**NYM/2020/0583/FL Newlands Farm, Newlands Road Cloughton – appeal statement response**

My name is Kay Aitchison and I am the officer for the Local Highways Authority, North Yorkshire County Council, (NYCC) who has assessed and made recommendations regarding the above application. In response to the appellants statement I would like to clarify the guidance used and the reasons for the recommendations made.

The crossing of the highway verge and footway must be constructed in accordance with the approved details and Standard Detail number **E30** and the following requirements.

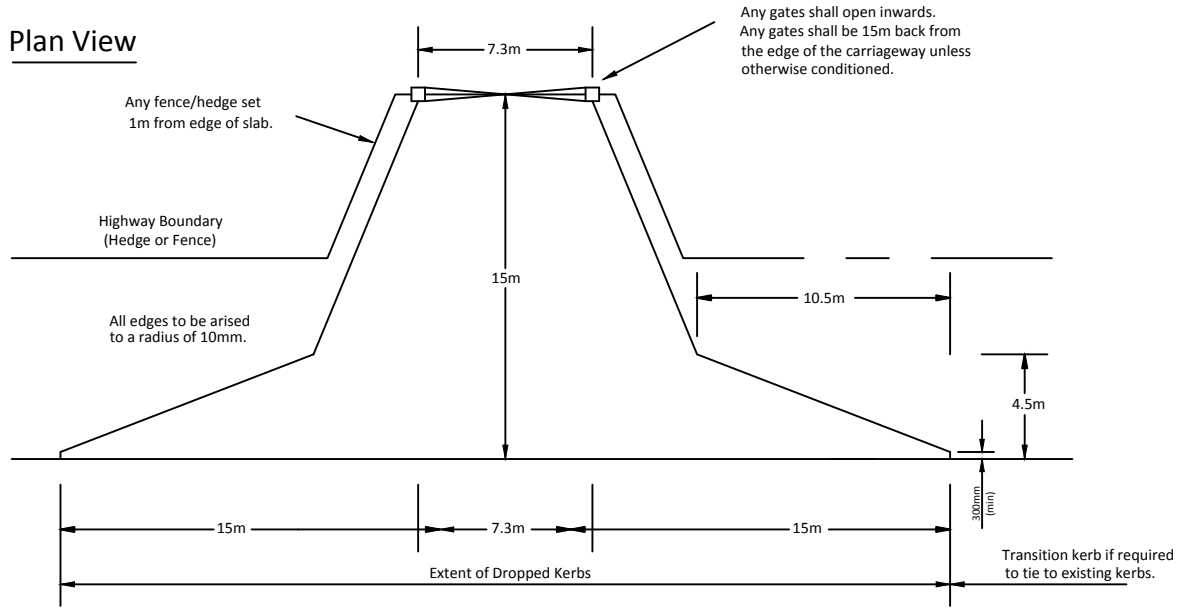
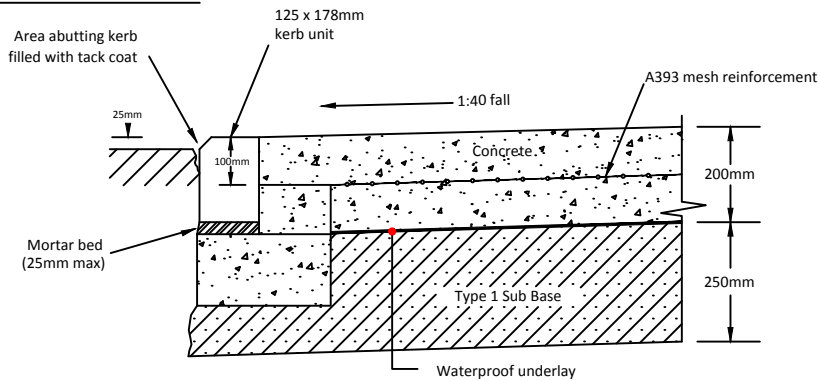
#### **MHC-03 New and altered Private Access Verge Crossing at NEWLANDS ROAD CLOUGHTON**

The development must not be brought into use until the access to the site **NEWLANDS ROAD CLOUGHTON** has been set out and constructed in accordance with the 'Specification for Housing and Industrial Estate Roads and Private Street Works' published by the Local Highway Authority and the following requirements:

- Any gates or barriers must be erected a minimum distance of **15 metres** back from the carriageway of the existing highway and must not be able to swing over the existing or proposed highway.
- Provision to prevent surface water from the site/plot discharging onto the existing or proposed highway must be constructed and maintained thereafter to prevent such discharges.
- The final surfacing of any private access within **15 metres** of the public highway must not contain any loose material that is capable of being drawn onto the existing or proposed public highway.
- Measures to enable vehicles to enter and leave the site in a forward gear.
